Model: Rmy-P1	Date: 17-Jul-13	No.: RM156001e
---------------	-----------------	----------------

Subject: Firmware Release Note: Main		Prepared by: Y. Miyamoto	
From: 1st Tech Service Sect., MFP/Printer Tech Service Dept.			
Classification:	<input type="checkbox"/> Troubleshooting <input type="checkbox"/> Mechanical <input type="checkbox"/> Paper path <input type="checkbox"/> Product Safety	<input type="checkbox"/> Part information <input type="checkbox"/> Electrical <input type="checkbox"/> Transmit/receive <input checked="" type="checkbox"/> Other (Firmware)	<input type="checkbox"/> Action required <input type="checkbox"/> Service manual revision <input type="checkbox"/> Retrofit information <input checked="" type="checkbox"/> Tier 2

Model: RM-MF		Date: 20-Nov-14	No.: RM156003
Subject: ADF part change information		Prepared by: T. Sakakibara	
From: 3rd Tech Service Sect., MFP/P Tech Service Dept.			
Classification:	<input type="checkbox"/> Troubleshooting <input checked="" type="checkbox"/> Part information <input type="checkbox"/> Action required <input type="checkbox"/> Mechanical <input type="checkbox"/> Electrical <input type="checkbox"/> Service manual revision <input type="

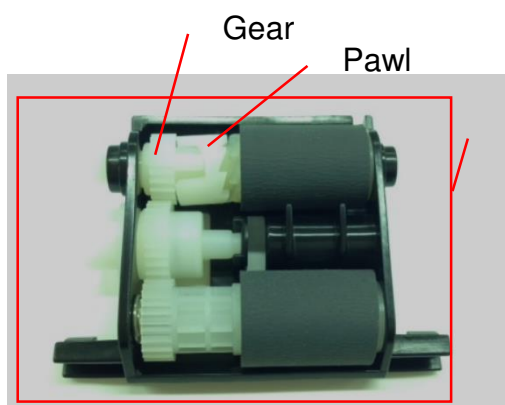
1. Material of the gear (M1562825) and the pawl (M2021773) used in the feed roller of the ADF feed unit were changed from nylon to POM (Polyoxymethylene).
2. Discharge brush (M2021779) was newly added.
3. PICKUP ROLLER:ASS'Y was newly available.

Above changes 1 and 2 were made to improve ADF no-feed problems in a low temperature and low humidity environment (LL environment: 10°C, 15% RH).

Both changes were made to neutralize static electricity.

Replace the entire PICKUP ROLLER:ASS'Y or ADF ASS'Y when its sub pieces are damaged.

M156/M157/M176/M177 Point to Point diagram:

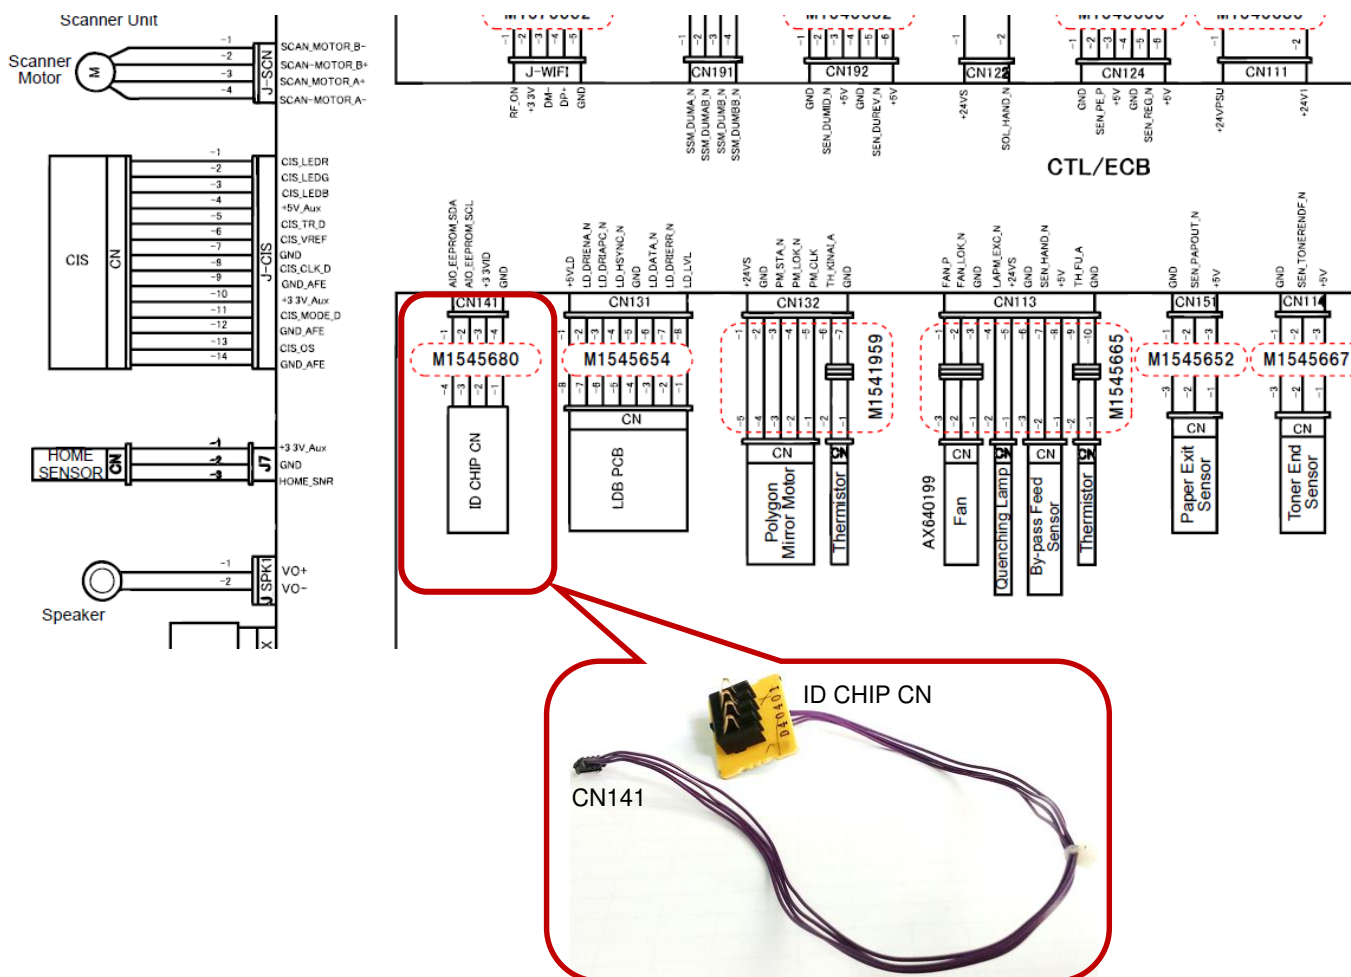
M1545680 has the ID CHIP connector.

Copier model SP mode

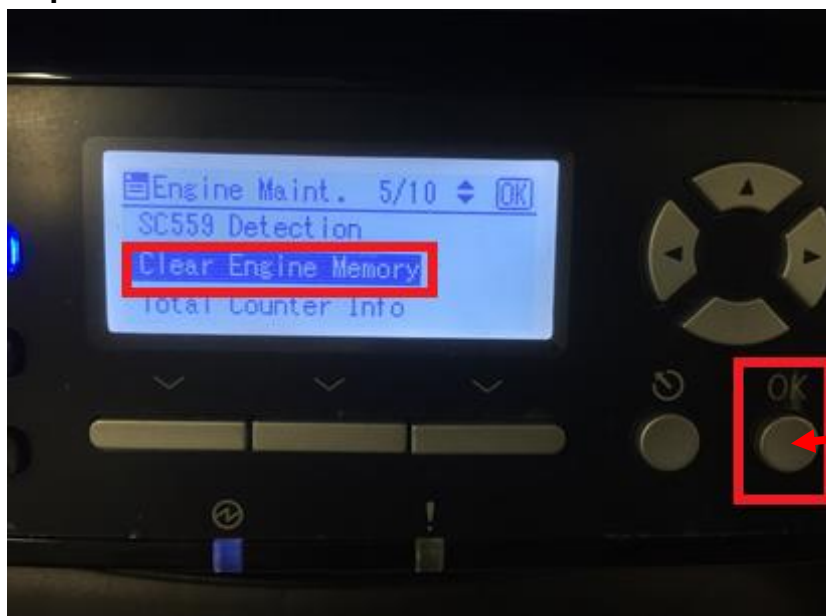
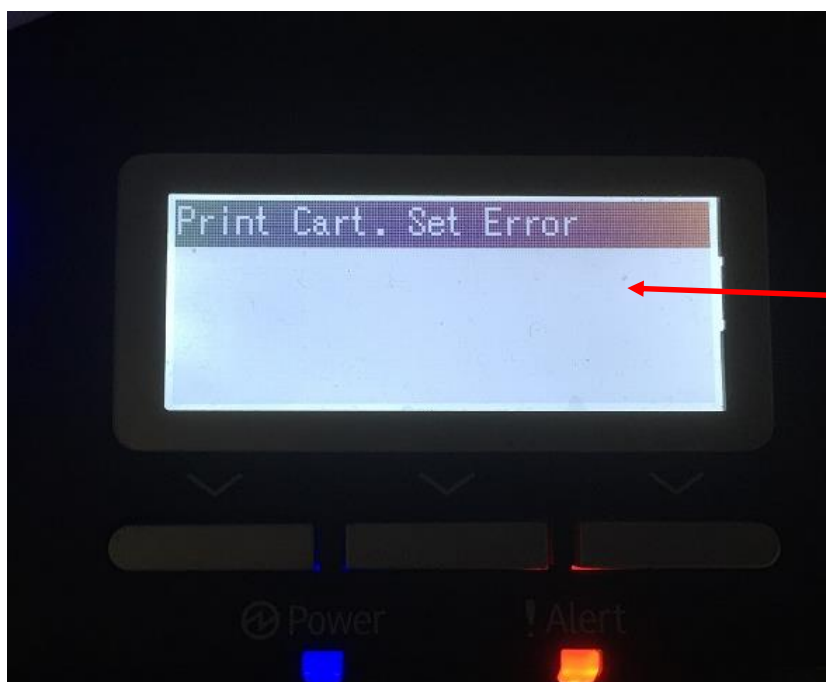
Clicking the "Clear Engine Memory" button in the SOM (printer configuration screen) or the SP mode will falsely reset all the engine related values stored in the main board, preventing the device from recognizing the AIO.

DO NOT select [Clear Engine Memory] and click OK!

Device no longer detects AIO.

If the Clear Engine Memory button had been pressed, update the Main firmware to "ver.1.04" or later to resolve the situation.

Printer model SOM

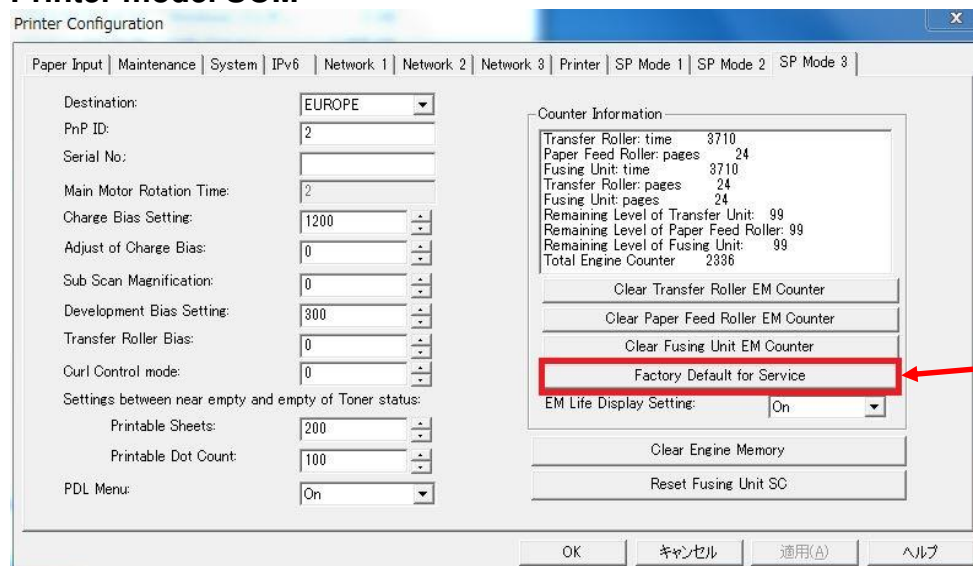
Click [Factory Default for Service].

Copier model SP mode

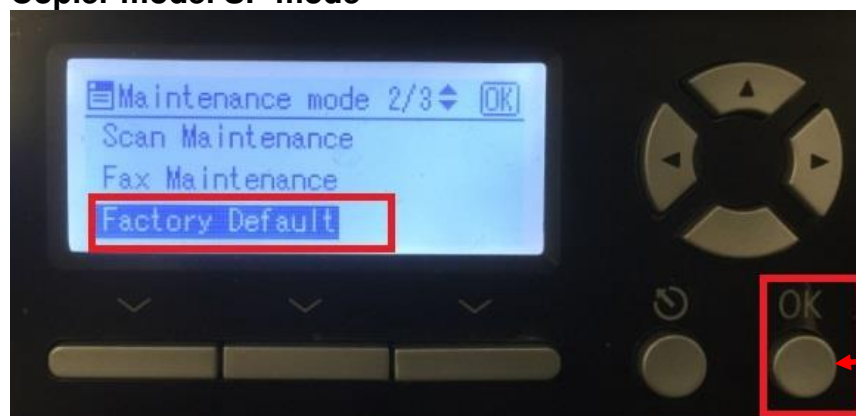
Select [Factory Default] and click OK.

Model Rmy-MF1 (TypeG)

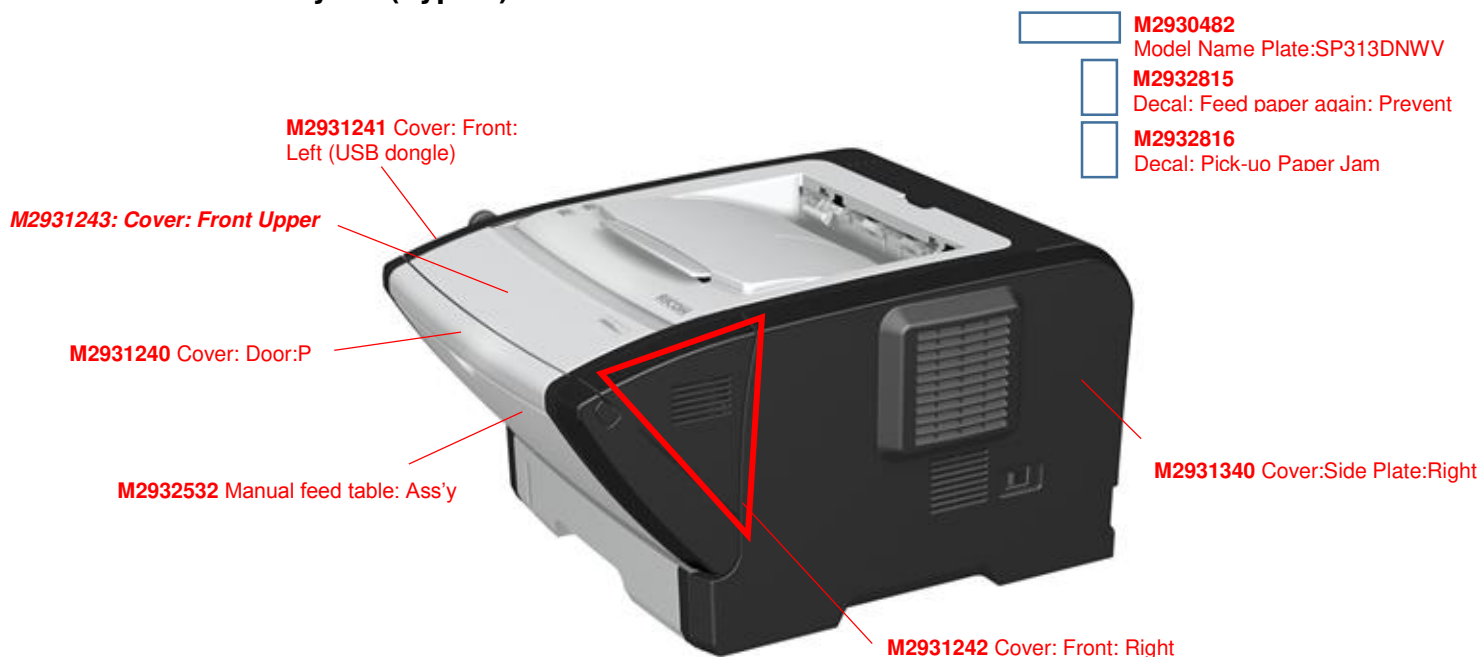
New parts are added as follows.
